Kembla Grange Resource Recovery Facility Modification 3

Extension of operation hours for transport of material, expansion of waste types and lighting upgrade.

State Significant Development Modification Assessment (SSD-5300-Mod-3).

December 2021

Figure 6 | Location of receivers near RRF site, by receiver type

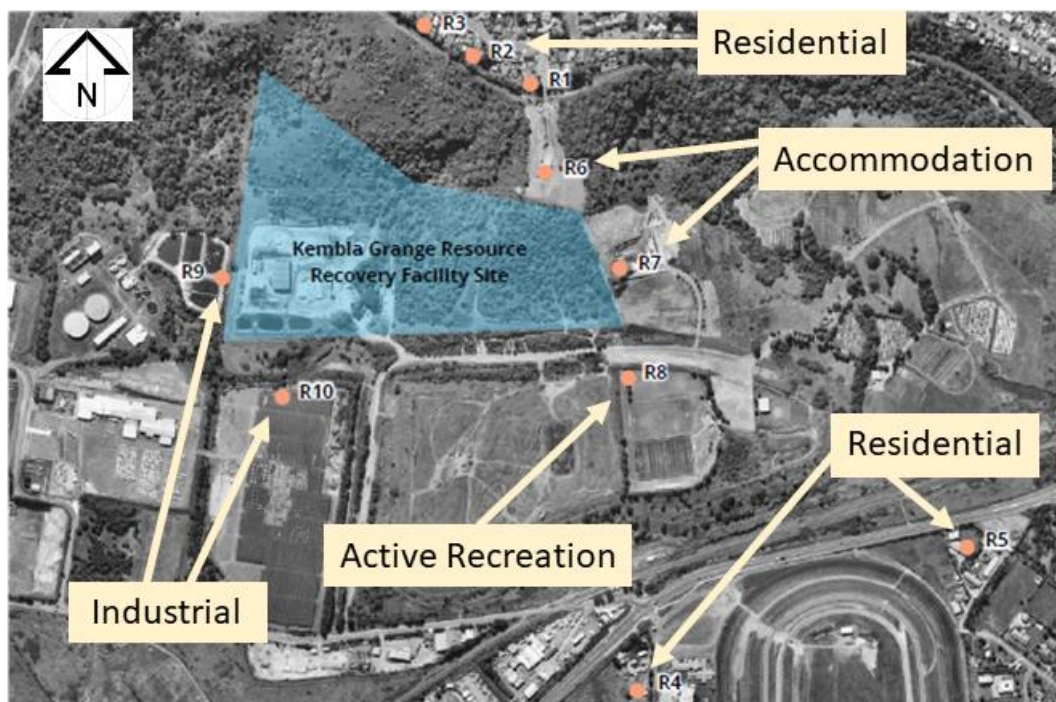
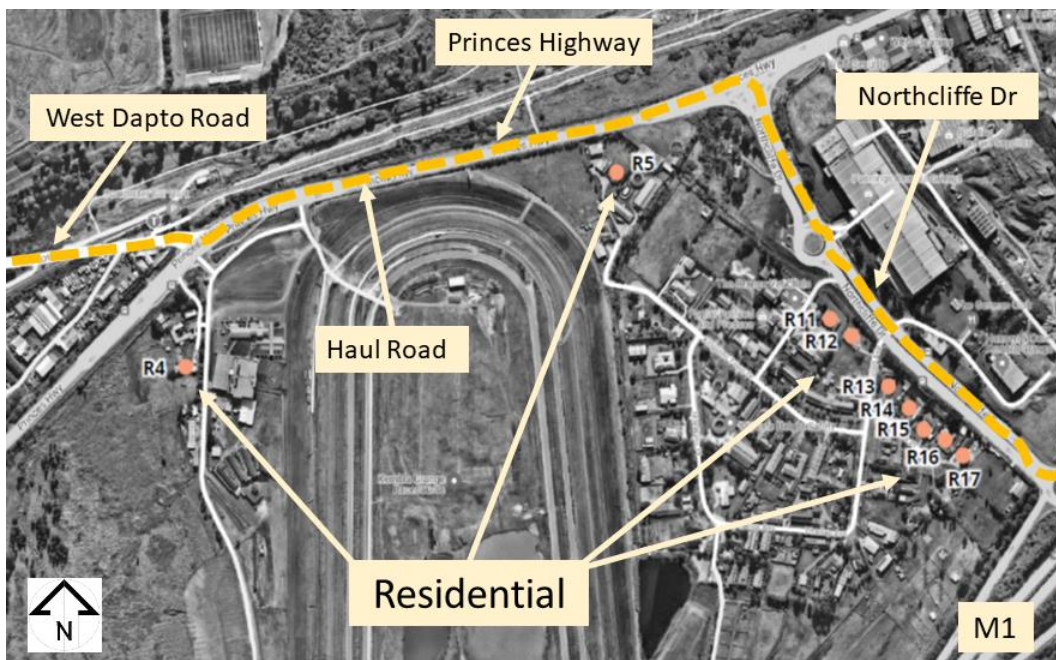
The EPA reviewed the NVIA and raised concerns about the modelling of surrounding topography as well as the sound power levels used. The Department also requested further information on sound power levels to ensure they were representative of the activities undertaken, including machines

dropping loads of waste into trucks, vehicle start up, and generators. The Department also requested further information on appropriate noise criteria for the Sveta Petka Monastery (R7) as it provides accommodation and therefore requires assessment for night-time sleep disturbance.

The Applicant provided an updated NVIA to address the matters raised by EPA and the Department. This confirmed and updated the noise measurements used for various plant, machinery and activities and provided amended Monastery accommodation night-time noise criteria of 43 dB(A) and sleep disturbance noise criteria of 52 dB(A) as required by the NPfl. The updated NVIA predicted noise emissions for $L_{Aeq(15min)}$ values for evening, night and morning shoulder, as well as L_{AFMax} sleep disturbance values for night and morning shoulder would remain less than the PNTL for each receiver type under noise enhancing conditions. As such, operational noise is not expected to impact on the acoustic amenity of the surrounding noise-sensitive receivers.

The EPA reviewed the updated NVIA and recommended updated noise limits for evening and night-time periods for Condition B20 based on outcomes from the updated NVIA.

The Department has considered the updated NVIA and the responses from the EPA. The Department notes the conservative assumptions provided in the NVIA and that the PNTLs for each receiver would be complied with for evening, night-time and morning shoulder periods.
